Product Change Notice (PCN)

PCN Number: PCN-0450965R-01

Product(s) Affected: MJ1-2503A

Comparison plastic housing as below:

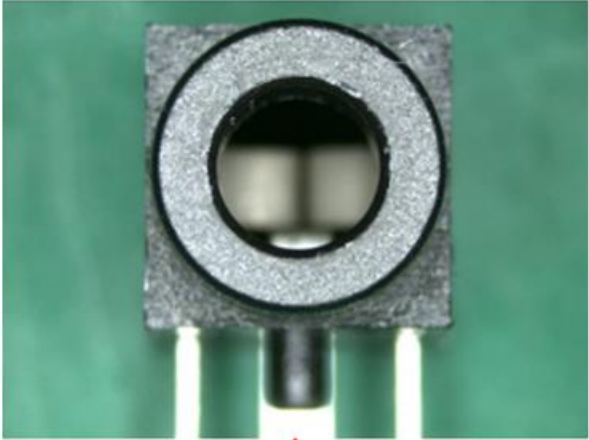
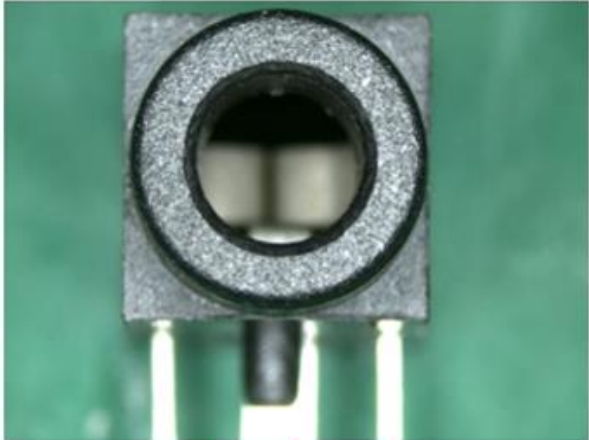
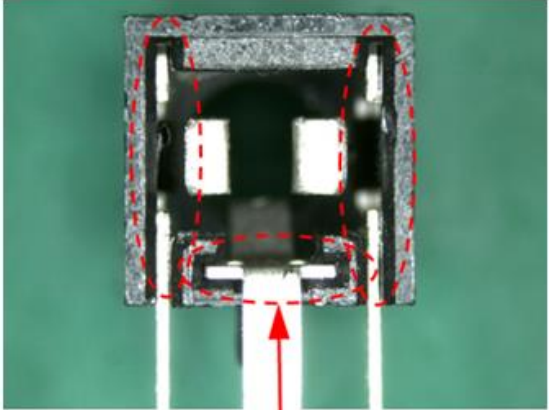
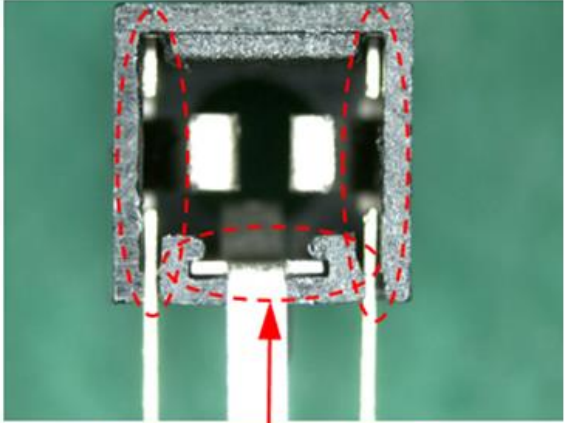
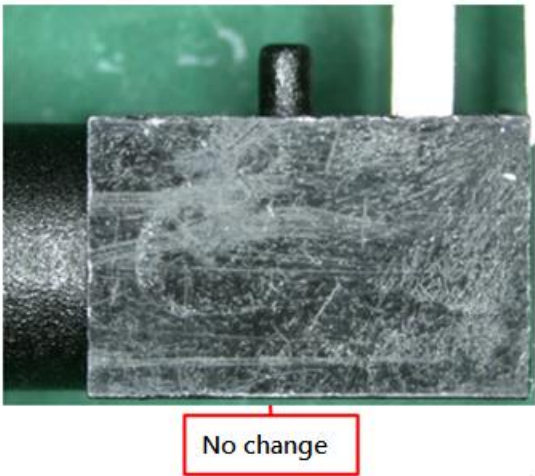
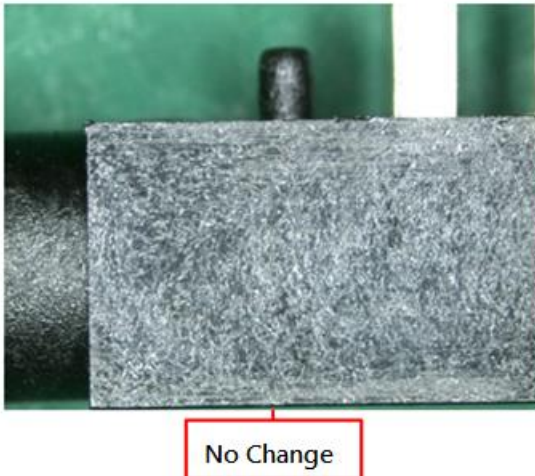
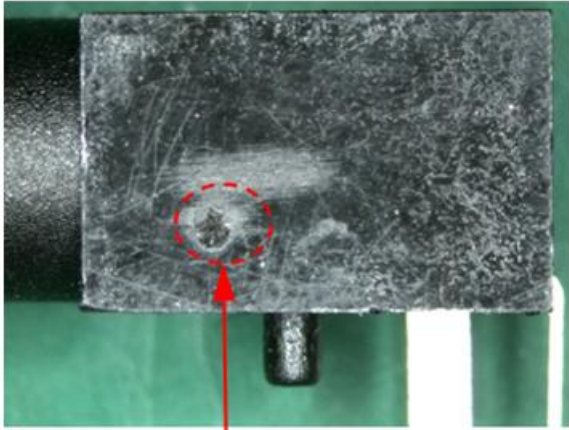
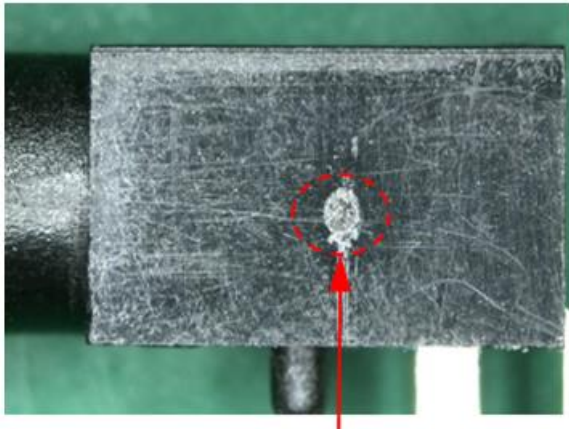
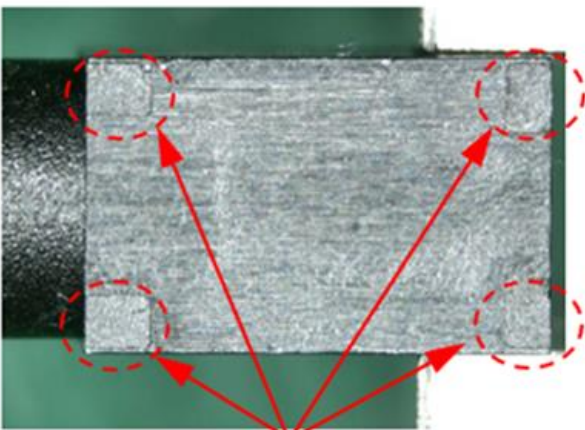
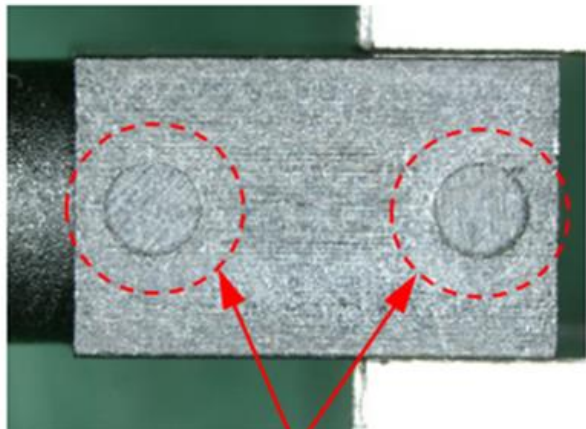
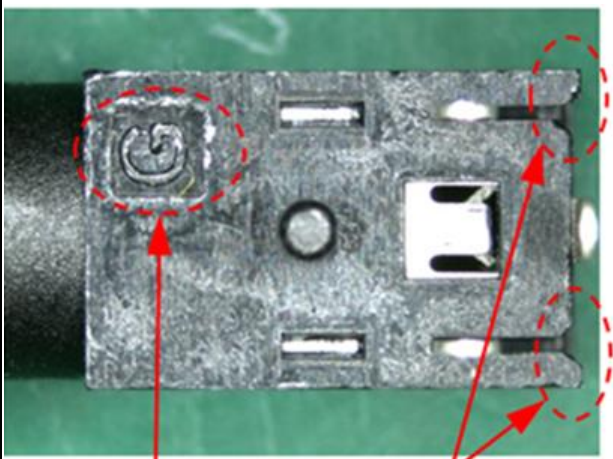
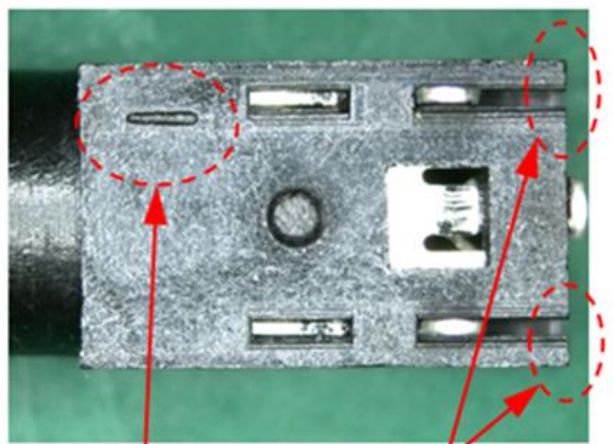
New version	Current version
Front	 <p>No change</p>	 <p>No change</p>
Back	 <p>add Chamfer</p>	 <p>No Chamfer</p>

<p>Left</p>	 <p>No change</p>	 <p>No Change</p>
<p>Right</p>	 <p>Injection point</p>	 <p>Injection point</p>
<p>Top</p>	 <p>with four square marks</p>	 <p>with two circle marks</p>

outlook different

add chamfer

outlook different

no chamfer
